**Northgate Apartments**  
10720 5th Avenue NE, Seattle, WA 98125  
10715 8th Avenue NE, Seattle, WA 98125

RECOMMENDATION MEETING  
October 19, 2015  
PROJECTS #3017692 & #3019072

EDG - OPTION C (PREFERRED)

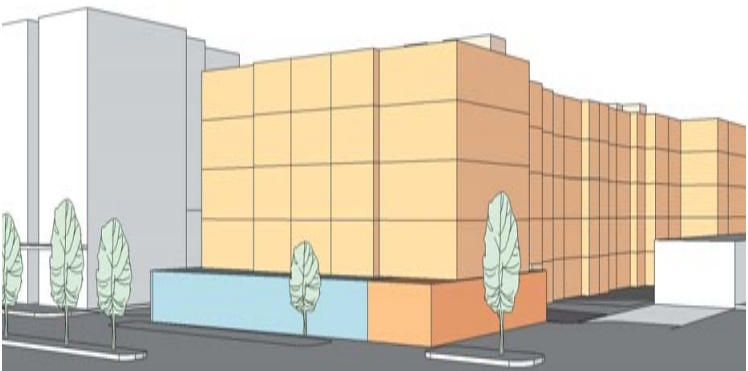
BOARD COMMENTS:

**CORNER RETAIL PLAZA:** The board agreed that retail space along 5th Avenue NE should incorporate an entry courtyard as shown in Option B.

**EAST / WEST PEDESTRIAN CONNECTIVITY:** Board felt that a pedestrian connection located North of the access easement and existing building colonnade, without stairs, provided the best solution for a variety of users.

**ENTRIES & ACCESS:** Board felt that the residential entry should in located to the West of the retail vehicular entry access drive as proposed in Option B to avoid mingling of pedestrian and vehicular traffic. Board noted the easement should be treated as a “private street” with the use of signage, street lamps, and pedestrian walkways.

**8TH AVENUE NE:** The massing of the East building should respect the lower residential scale of the 8th Avenue NE streetscape.

**LIVE / WORKS:** The board felt that the live work use should have its own commercial character with distinct but cohesive entries in coordination with the residential entries. In addition, a landscape barrier should be included between the sidewalk and the live / work units balancing privacy and “eyes on the street”.

BOARD COMMENTS:

**NORTH / SOUTH PEDESTRIAN CONNECTIVITY:** The board strongly encouraged the inclusion of a North / South pedestrian connection that would connect the property to the North with the East / West connection running adjacent to the access drive. The board agreed that barrier free access was an unlikely attainable due to the existing topography.

**PARKING & ACCESS:** Board supported Option C placement of vehicular parking access locations along the easement drive, with the retail parking access specifically located behind the retail use. And the residential vehicular access point should not be located directly across from the neighboring tenant space.

**ENTRIES & ACCESS:** Due to the presence of two streets, a private through street, and multi-directional pedestrian connectivity, wayfinding is critical for all types of users. Project should demonstrate a comprehensive plan for movement for users and all modes of travel.

**RESIDENTIAL ENTRIES:** Board felt primary residential entries should be located along the street frontage. Alternatively, the project will need to demonstrate the rationale for primary entries being located at the center of the site and how all users will find the residential entry points.

RESPONSE TO GUIDELINES: PLAN OF CENTER ARRIVAL COURT

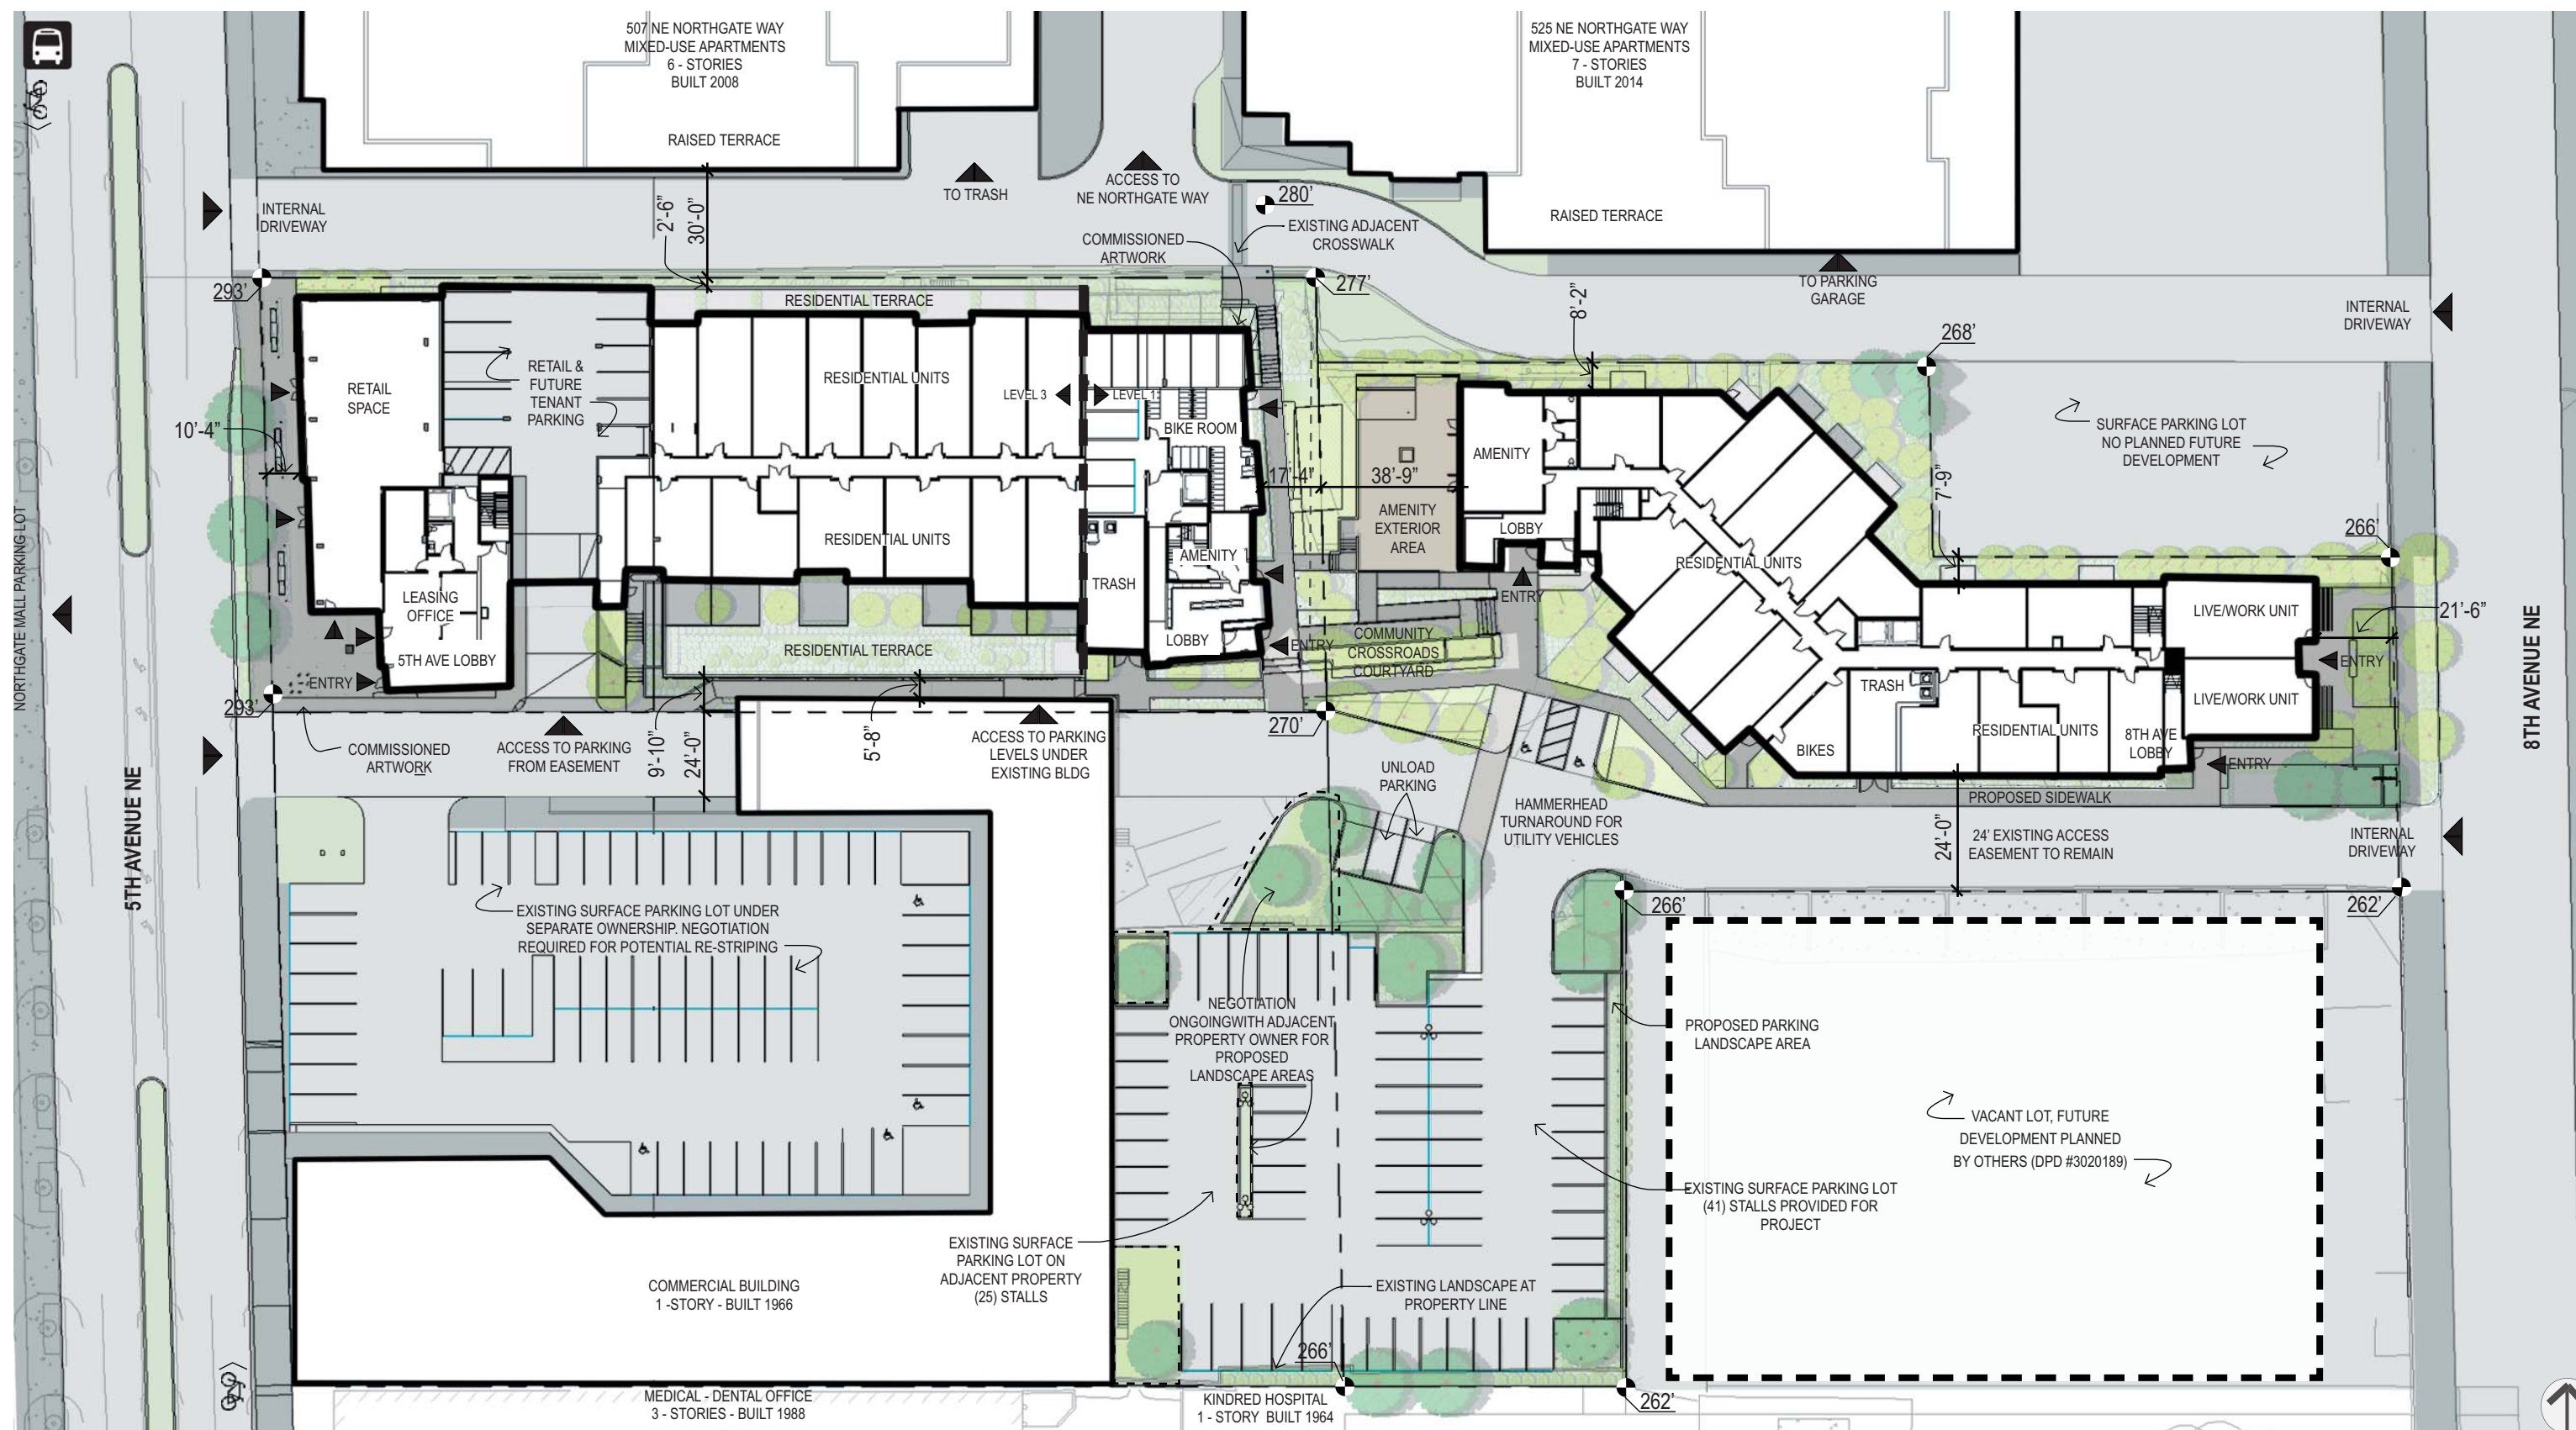
**PL2.D:** Wayfinding - Use design features as a means of wayfinding and provide clear directional signage where needed.

**PL3.A1:** Entries, Design Objectives - Design primary entries to be obvious, identifiable, and distinctive with clear lines of sight and lobbies visually connected to the street. Differentiate residential and commercial entries with design features and amenities specific to each.

**PL3.A2:** Entries, Ensemble of Elements - Design the entry as a collection of coordinated elements including the door(s), overhead features, ground surface, landscaping, lighting, and other features.

**PL3.B:** Residential Edges - Provide security and privacy for residential buildings through the use of a buffer or semi-private space between the development and the neighboring streets / buildings. This is particularly important in buildings with ground-level housing, both at entries and where windows are located overlooking the street and sidewalk.

**PL3.B3:** Buildings with Live/Work Uses - Use active and transparent facades and face the non-residential portions of the live/work unit toward the street.

**PL3.C:** Retail Edges - Engage passersby with opportunities to interact with the building interior using glazing and transparency. Allow spaces for activities to extend into the public areas.

**PL4.A:** Entry Locations and Relationships - Provide safe and convenient access points for all modes of travel. Site the primary entry in a location that logically relates to the building uses and clearly connects all major points of access.

**DC1.B:** Vehicular Access and Circulation - Choose locations for vehicular access, service uses and delivery areas that minimize conflict between vehicles and non-motorists.

**DC1.C4:** Parking and Service Uses - Locate and design service entries away from pedestrian areas or to less visible areas to reduce the impact of these uses on circulation.

**1 RESPONSE:** Project proposes signage oriented to vehicular traffic which is visible from the Avenues (parapet and facade locations) and also within the site for clear passage to designated long and short term parking areas (parking signage and monument signage). For pedestrians, the use of human scaled street lighting poles and predictable pathway lighting mark the pedestrian connectivity paths. Entries are marked with articulated awnings containing unique building signage. Specialty paving at important path transitions is also proposed.

**2 RESPONSE:** Residential building entries are provided off of the 5th and 8th Avenue NE Streetscapes to give tenants and guests direct access to the residential entries from the public right of way. Additional building entries are located mid-site within the Community Crossroads courtyard engaging the public along the internal pedestrian connectivity pathways. To distinguish commercial / live-work entries with residential entries, strategies of differing awning designs, signage configuration, and architectural building massing is used.

**3 RESPONSE:** The live / work uses have a 21’ setback from the sidewalk along 8th Avenue NE to preserve the live / work tenant’s personal space as well as providing a greenspace buffer fronting the public realm. In addition, buffer plantings areas are provided along both edges of the live / work patio spaces between future development to the North and the pedestrian access to the residential tower.

**4 RESPONSE:** The live / work entries face 8th Avenue NE and have each has direct unique access points from the sidewalk. The commercial uses within the unit front 8th Avenue NE and maintain large front windows and transparency while still creating wall opportunities for business signage and lighting.

**5 RESPONSE:** Along 5th Avenue NE, the retail frontage maintains direct access from the sidewalk. At the SW corner of the site, open space is provided to separate the residential entry and leasing office from the retail frontage. This open space is utilized for public art / sculpture display.

**6 RESPONSE:** Residential building entries are provided off of the 5th and 8th Avenue NE Streetscapes to give tenants and guests direct access to the residential entries from the public right of way. The additional mid-site entries within the Community Crossroads courtyard support the idea that the access easement drive is a “street” by bringing activity to the length of the drive, bringing “eyes on the street” to the central intersection of the publicly accessed North/South and East/West pedestrian connections, strong connections to drop-off and pick-up points, and strong inter-building connections for tenants sharing amenities such as social areas and structured parking.

**7** **RESPONSE:** All vehicular parking access points are from the easement drive. The retail vehicular parking is located to the East of the retail, leasing office, and residential entry locations so that pedestrian users have direct access to those building amenities from the street without crossing vehicular traffic. The residential structured parking access is located so that is offset from the existing adjacent commercial space to avoid light and glare and protect that entry from traffic.

**8** **RESPONSE:** Due to the presence of the easement drive and the narrow street frontage of the project site, utility uses are placed along the easement for access. Entries are placed as far away from the pedestrian pathways as possible while still providing convenient access for service. The tunnel clearance over the easement does not allow a refuse and recycling vehicle to pass under it. Utility vehicles will need to access the site from 8th Avenue NE to access the service areas for both the East and West buildings. A 60’ long hammerhead turnaround space with 20’ radius turns is provided so that utility trucks can turn around within the site. Trash pick-up locations and the turn-around access have been reviewed and approved by Seattle Public Utilities.

**9** **RESPONSE:** Project proposes both a North/South and a East/West pedestrian connection through the site. The North/South connectivity connects the 525 Northgate Way existing sidewalk and intended crosswalk to an active intersection with the East/West connection within the Community Crossroads courtyard mid-site. The East/West pathway connects 8th Avenue to 5th Avenue and follows the easement drive which is intended to be an internal “street” enriched with pedestrian friendly elements such as benches, lighting, and plantings.

**10** **RESPONSE:** 5th Avenue streetscape is envisioned as an active retail sidewalk continuing the pedestrian friendly experience as developed to the North. Project proposes the use of overhead weather protection, clear retail signage, transparency beyond code minimums along the sidewalk and around building corners to eliminate blank wall conditions to the North along the adjacent access drive and opening to the South at the SW corner plaza.
